WATERFORD SCHOOL
SPORTS FIELD AND
PARKING

WATERFORD SCHOOL PARKING ADDITION

OVERALL SITE PLAN

GRADING AND
DRAINAGE PLAN

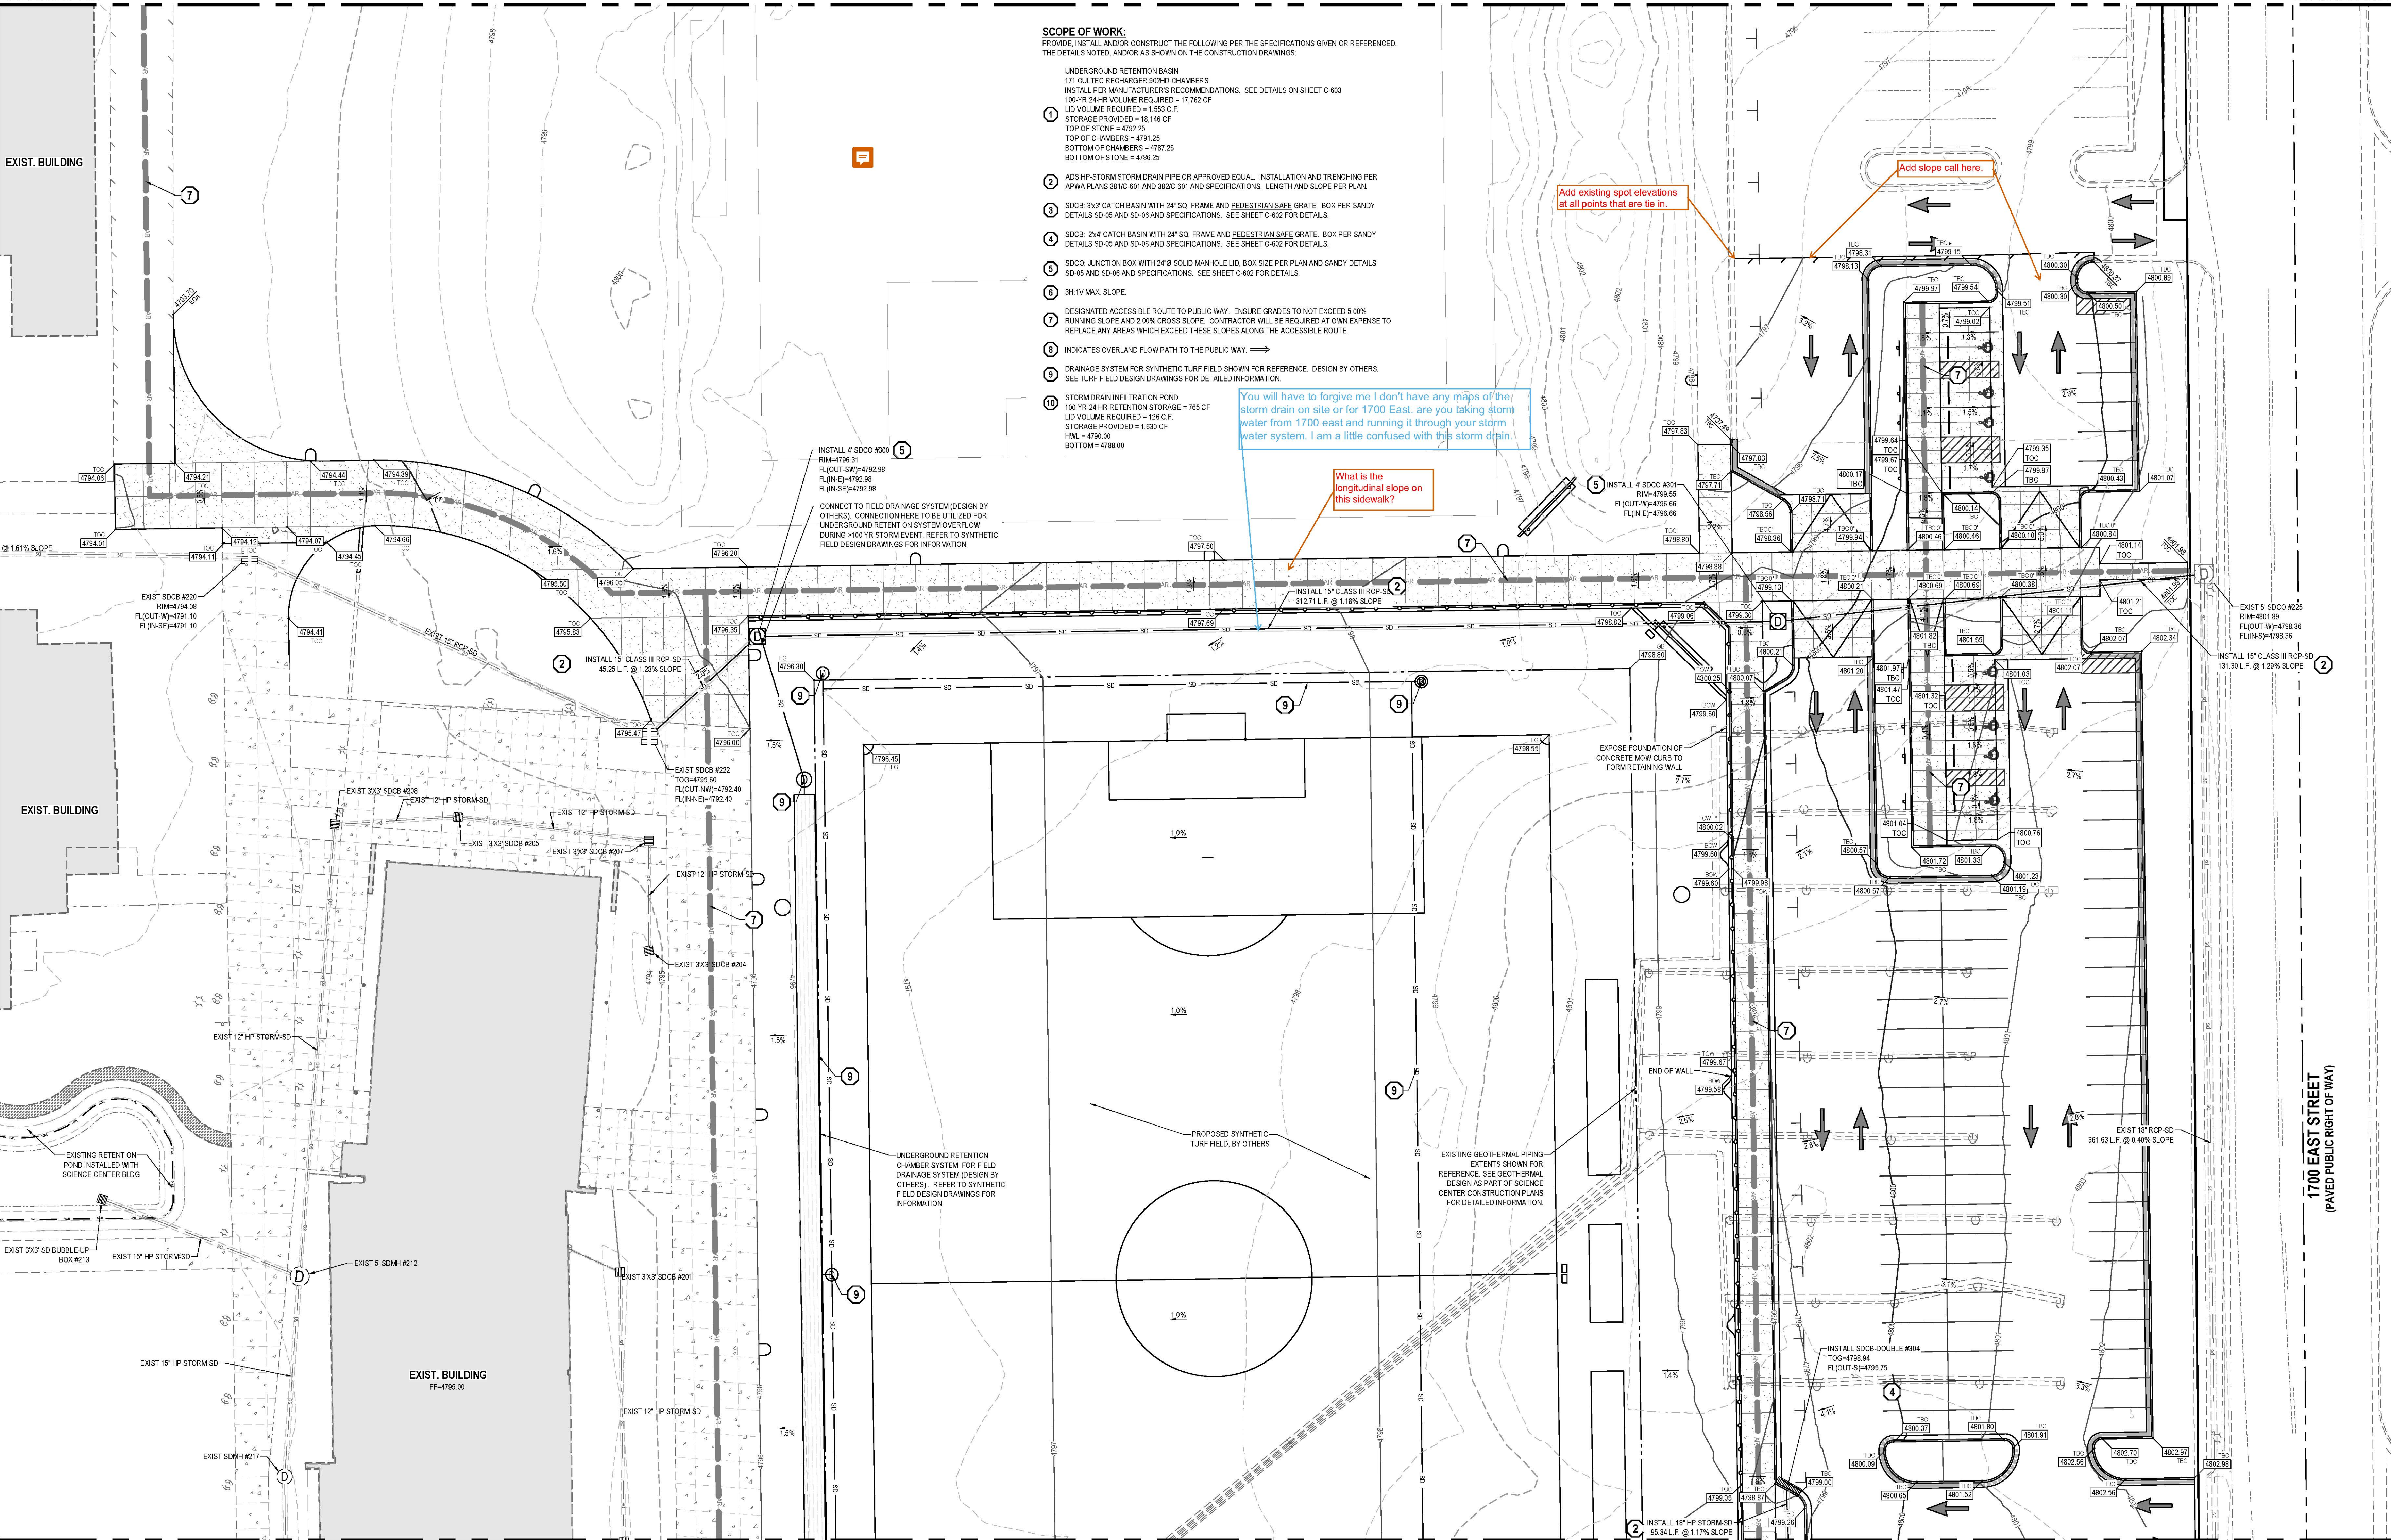
Does this go to Shoshone ave? We need to ensure that this flow will not effect structures. we will need an exhibit and narrative in the drainage report addressing this.

Need to show existing storm drainage system.

Is this going to be a ponding issue? Add some existing grades outside the LOD to show flows will not stop. Typical on all tie in locations for the grading plan.
